ENCLOSURE 2

MFN 03-070

Response to NRC RAI numbers (13, 14, 28-30, 33, 34, 36-44, 46, 49-53, 55, 57-59, 61-64, 66, 68, 69, 72-76, 78, 80, 81, 83-85, 88, 93, 96, 98, 99, 102-104, 107, 108, 110-112, 147-150, 153-158, 163, 165, 166, 168-175, 178-182, 185, 186, 188, 189, 192-194, 196-201, 203-212, 215-219, 221-224, 226-230, 233, 235, 237-256, 263, 265, 267-270, 273, 274, 278, 280, 283-285, 287-289, 291, 300, 302, 303, 318, 320, 322, 328, 332, 340-344, 348, 361, 362, 364-370, 377, 386, 407, 409-413)

Figure 14-1 PCC and Decay heat Power for Base Case

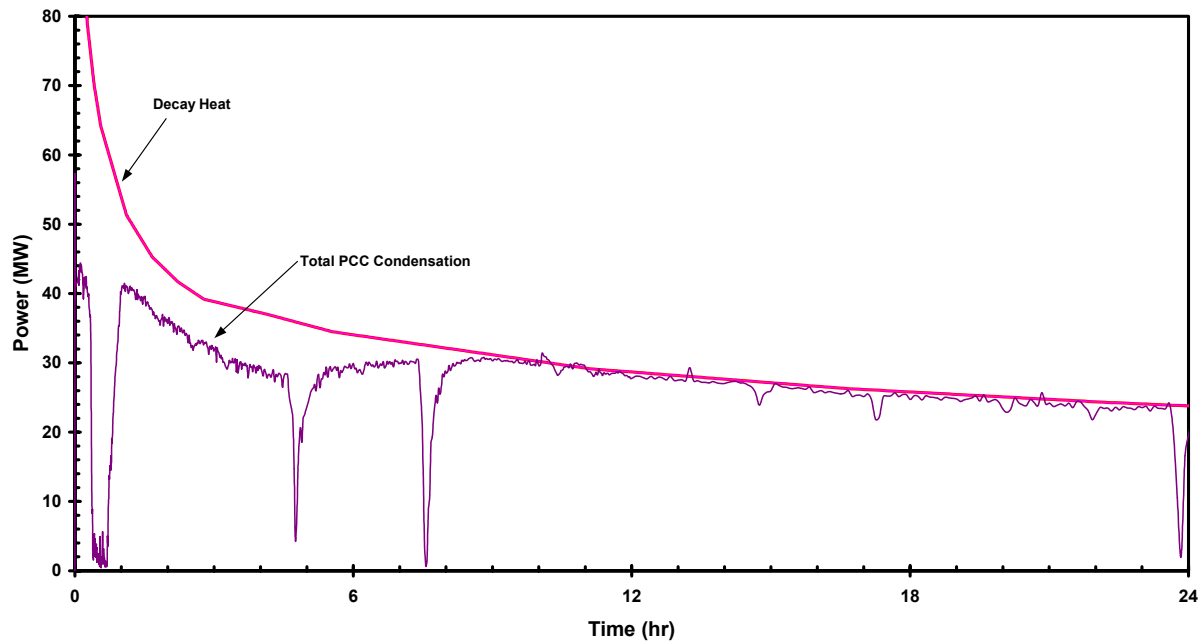
Q14. Surface-to-Volume ratio of PCC headers :

In the 2nd paragraph, page 8-5 of the Scaling report (NEDC-33082P), it was stated that because the surface area to volume ratio is increased for the reduced length headers of the passive containment cooling system (PCCS) in the testing facilities (PANDA, PANTHERS), the heat removal through the header walls was increased. The staff realizes that the heat loss in the headers is much less compared to that through the tube walls. However, a higher heat loss through the headers results in increased total heat removal capacity for the PCCS in the tests (non-conservative effect), and this may have an impact on the containment pressure. The staff, therefore, requests that GE provide an estimate as to how a distortion in PCCS heat removal capacity will impact the peak containment pressure.

- R14. The additional heat loss through the headers does not have a significant effect on the containment pressure. As noted in Section 7.6 of the ESBWR Scaling Report, the total capacity of the PCC is only important during periods where the demand for heat removal is greater than the maximum capacity of the PCC. For all other periods the PCCs will self regulate to the demand level. An example is given in Figure 14-1 which is the base case TRACG prediction for the ESBWR main steam line break (previously presented as Figure 3.7-6 in NEDC-33083P). Figure 14-1 illustrates that the heat removal demand is greater than the PCC's ability to remove heat for approximately the first eight hours. It is during this interval that increased surface area (i.e. a larger header) would provide additional benefit. Beyond eight hours the PCC has excess heat removal capacity and self-regulates to match the decay heat load. Therefore excess capacity in the header has no influence on the PCC heat removal or the system behavior. To quantify the impact of excess heat removal capability in the PCC, sensitivity cases were performed using TRACG with excess heat removal capacity through the PCC header.

Figure28.1

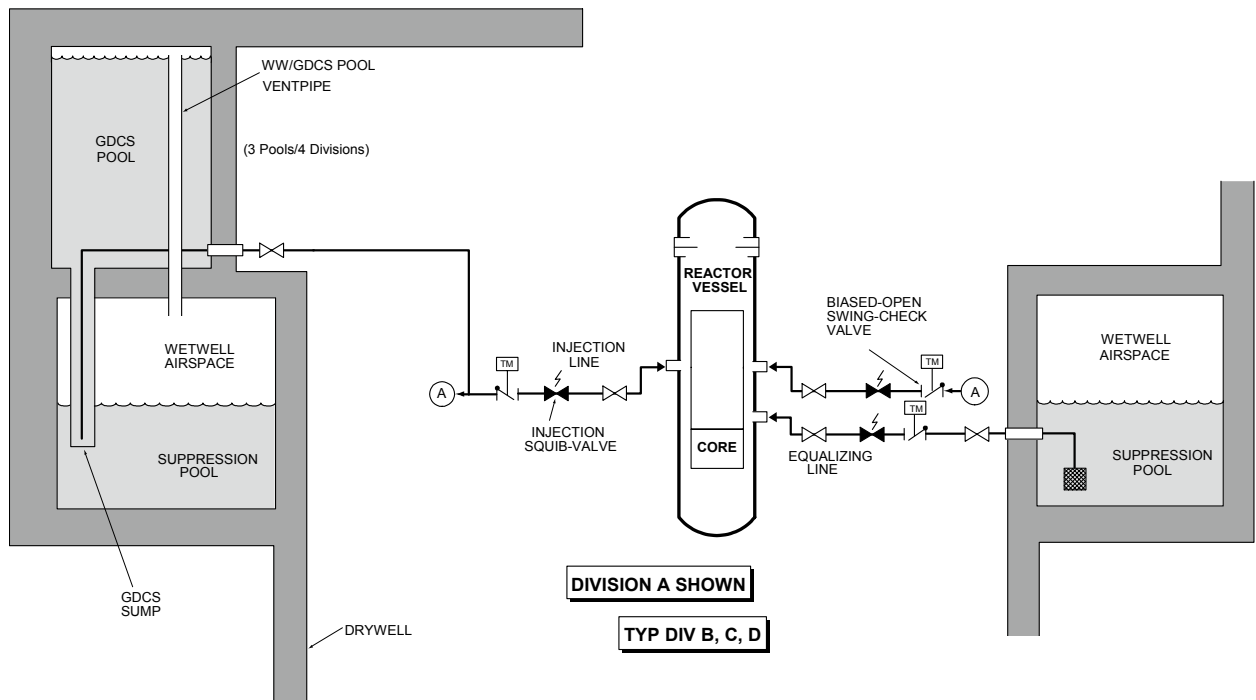
- Q28. The passive containment cooling system (PCCS) performance depends on the pressure difference between drywell (DW) and wetwell (WW) and not having any other path than the PCCS (the only path between them being through the PCCS). A GDCLB with a single failure of the check valve can potentially create bypass between DW and WW, and compromise the PCCS performance. Please explain why this is not considered or why this is not possible.

- R28. Please refer to the simplified system schematic (figure 28.1), which shows that the GDCLB suction line is placed in a long, vertical sump that extends several meters below the bottom elevation of the GDCLB Pool. The GDCLB sump is formed from a heavy-walled stainless steel pipe that runs adjacent to the outer bounding wall of the suppression pool and is structurally supported from this wall. The GDCLB injection piping in this region reaches downward to the sump bottom but maintains an appropriate clearance such that inordinate flow entry losses are avoided. The depth and diameter of the sump are selected to ensure that the necessary residual inventory of water to maintain the loop seal intact and functioning is always present throughout the post-LOCA period.

If the GDCLB injection line to the vessel were to break at a non-conservative location and the biased open check valve failed, water would siphon out of that GDCLB pool, flooding the lower drywell as designed. The water in the suction line sump would only drain down to the level of the lowest pipe break elevation, leaving water in the sump to provide a seal sufficient to prevent bypass flow from the drywell to wetwell or vice-versa.
